# DART SERVICE BULLETIN SB11-3

**D206-558-041 SINGLE MIRROR INSTALLATION AT CHANGE 006 OR EARLIER**  
**D206-558-043 DUAL MIRROR INSTALLATION AT CHANGE 006 OR EARLIER**

## D206-558-041/-043 SINGLE/DUAL MIRROR INSTALLATION

### REPLACEMENT OF D2065 ARM ON D206-558-041 SINGLE MIRROR INSTALLATION :

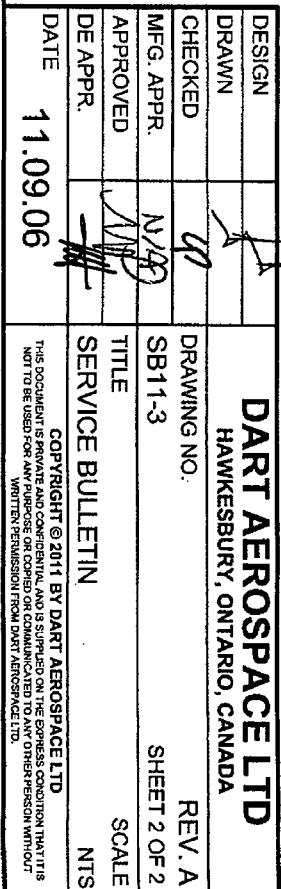
Dart Aerospace Ltd. has received information indicating that under certain circumstances on **D206-558-041/-043** Cargo Mirror Installations at **CHANGE 006 or earlier**, the D2065 or D2066 Arm may crack during flight, and could cause the D2011-101 mirror to separate from the assembly and depart the aircraft in flight.

Dart Aerospace Ltd. recommends that operators with aircraft equipped with **D206-558-041/-043** Cargo Mirror Installations at **CHANGE 006 or earlier** amend the daily preflight inspection by checking D2065 or D2066 Arm for cracks. If a crack is noticed, operators must perform the following as applicable:

1. Remove and discard existing D2065 Arm and D2057 Plug.
2. Procure improved D2065 Arms and D2057 Plugs from Dart Aerospace Ltd. referencing this Service Bulletin.
3. Install improved D2065 Arm and D2057 Plug in accordance with Figure 2 of D206-558, Figure 25.2 of ICA-D206-558, or Figure 1 of this service bulletin.
4. Install D2011-101 Mirror to replacement D2065 Arm using D3014-1 Locknut as shown in Figure 3 of D206-558, Figure 25.3 of ICA-D206-558, or Figure 1 of this service bulletin.

1. Remove and discard the existing D2066 Arm and associated parts/hardware. Per DSI 9416, the D2066 Arm also includes 2 X D2052 Brackets, 2 X D2055 Clamps, a D2056 Bellcrank, 2 X D2054 Bushings, and attaching hardware.
2. Procure improved D2066 Arms from Dart Aerospace Ltd. referencing this Service Bulletin.
3. Install improved D2066 Arm in accordance with Figure 2 of D206-558, Figure 25.2 of ICA-D206-558, or Figure 1 of this service bulletin.
4. Install D2011-101 Mirror to replacement D2066 Arm using D3014-1 Locknut as shown in Figure 3 of D206-558, Figure 25.3 of ICA-D206-558, or Figure 1 of this service bulletin.
